Work Order ID 136193

Item Name: Strut Doubler

APICAL INDUSTRIES, INC.	ENGINEERING CHANGE NOTICE NO. 03985			SHEET 1 OF 2	
	DWG NO. 647.0100	REV: A	PREPARED BY J. BECKER	DATE: 7/15/13	EFFECT ON DWG ☐ INC. ☒ UNINC.
	DWG TITLE: SHEET METAL				
APPROVED BY: ENGR. 		MFG 	QC 	EFF. NEXT ORDER	
TRANSACTION CODES (TC): A-ADD C-CREATE R-REVISE D-DELETE		REASON: REVISED NOTE 2. ADDED 647.0117

SHEET 1, ZONE D1 IS:

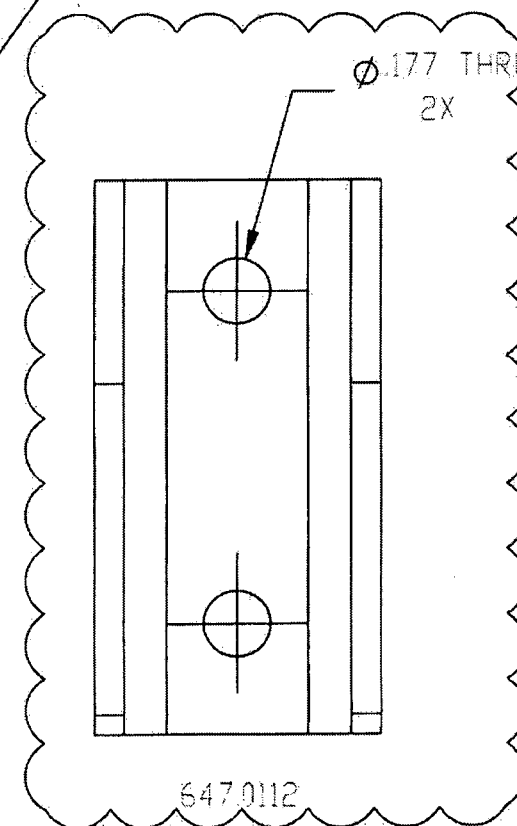
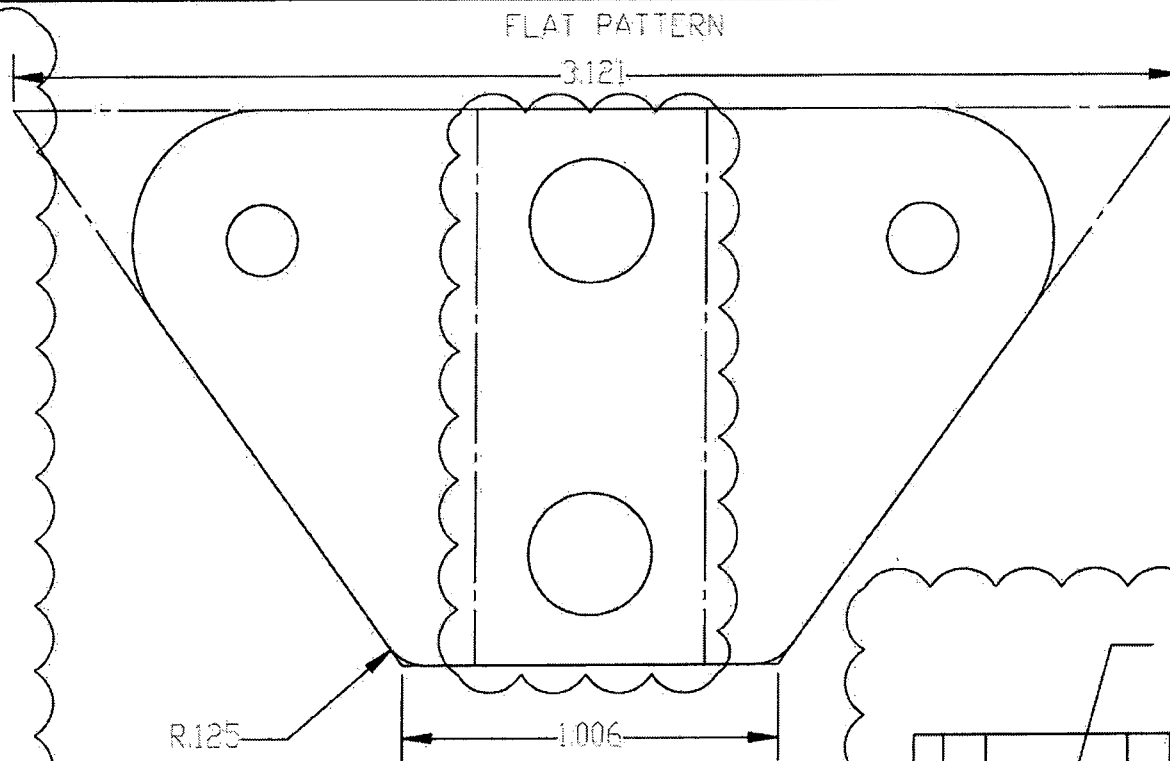
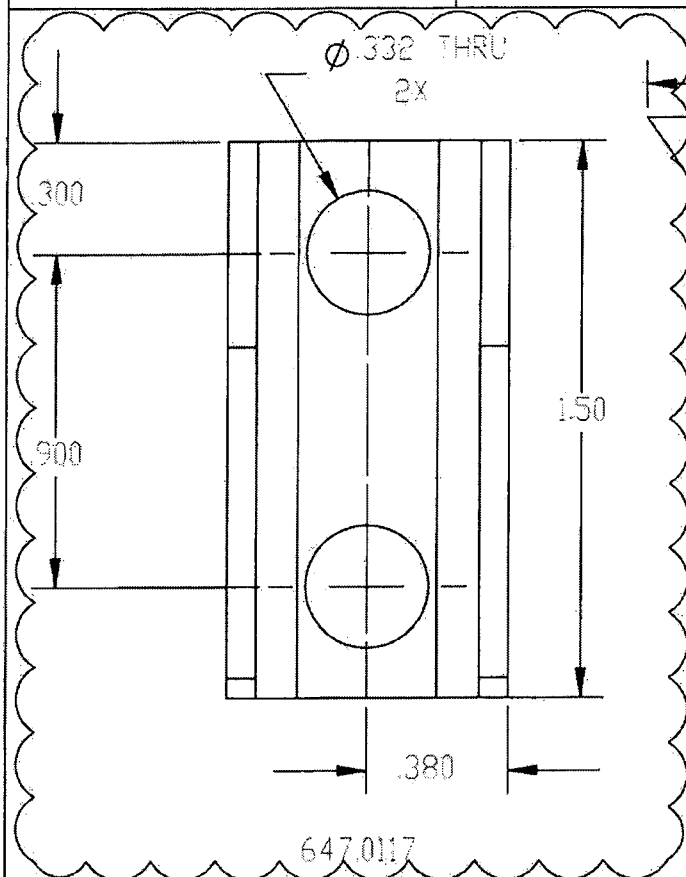
- 1 MATERIAL: ALUMINUM 2024-T3 PER AMS-QQ-A-250/4.
- 2 FINISH: IAW MPP-172 ANODIZE IAW SECTION 2.1,
PRETREATMENT IAW SECTION 3.1
AND PRIMER IAW SECTION 4.1.
3. DEBURR AND BREAK ALL SHARP EDGES.
4. IDENTIFY IAW MPP-120.
- 5 MATERIAL: 304 SS IAW AMS 5643.
- 6 FINISH: PRIME IAW MIL-P-23377J TYPE I CLASS N.
- 7 OTHER DIMENSIONS SAME AS 647.0112.

C	647.0117		STRUT BRACKET	△	△
F/N/TC	PART NUMBER		DESCRIPTION	MATERIAL	SPECIFICATION
DOCUMENTS EFFECTED:			CHANGE CATEGORY	DER REVIEW REQUIRED	
☐ MDL ☐ INSTALL INSTRUCTIONS ☐ ICA ☐ FMS ☐ BOM			☐ MAJOR ☒ MINOR	☐ YES ☒ NO
